Comments on the Integrated System Plan (ISP) 2025-35

By: Alliance for Climate Justice and Clean Energy (ACJCE)

Dated: September 27th, 2025

Subject: Comments on the ISP 2025-35 by the Alliance for Climate Justice and Clean Energy (ACJCE)

Graph 1: annual emissions by plant (ACJCE calculations)

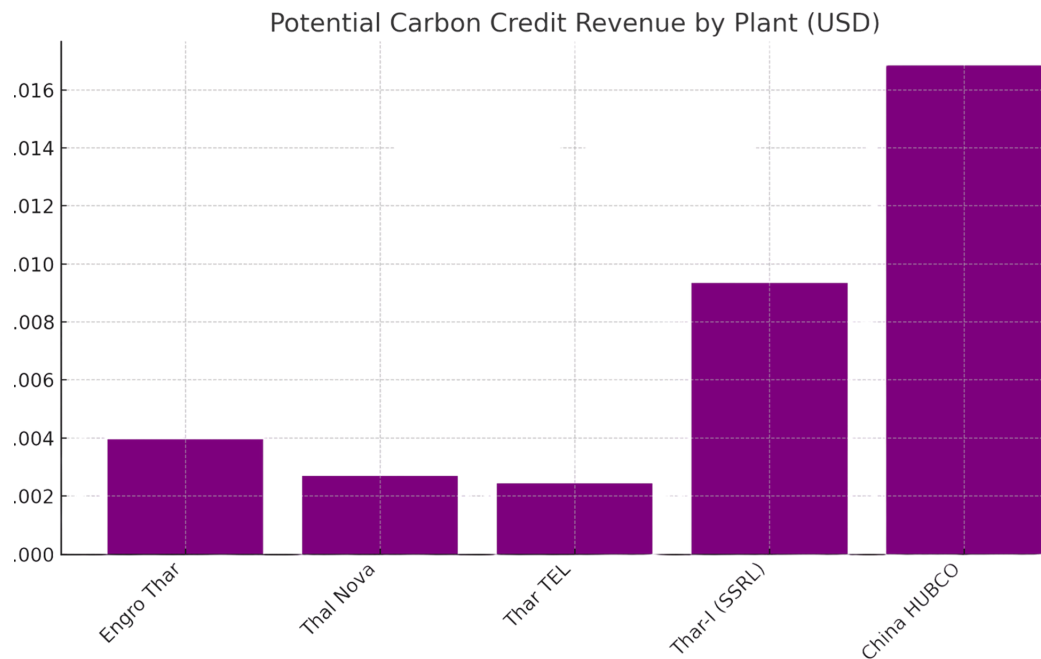
The economic consequences of this blind spot are far from abstract. Analysis suggests that Pakistan is foregoing approximately USD 0.7 billion in potential carbon-credit revenue per decade from just five existing coal plants⁶⁵. This foregone finance represents not only a missed opportunity for reducing fiscal stress in the power sector but also a significant deviation from the country's stated policy goal of accessing international climate finance flows. If carbon pricing is factored into system costs, displacement of coal becomes not only an environmental imperative but also a financial necessity. Graph 2 shows potential carbon credit revenue lost by 5 major coal plants amongst Pakistan's energy mix.

1. The system-wide least-cost gains from replacing coal and gas with renewables.
2. The total economic impact of foregone carbon credits if fossil plants are retained.
3. The network and security implications of early retirements, including TSEP-linked reinforcements.

Absent such analysis, the IGCEP and TSEP effectively default to a static fossil-heavy portfolio, which is inconsistent with both AREP and NEP policy mandates. More critically, this failure deprives decision-makers of the analytical tools required to weigh the real trade-offs between fossil lock-in and renewable transition. In doing so, Pakistan risks committing to an electricity system that is costlier, dirtier, and financially shortsighted, undermining its own least-cost planning principles.
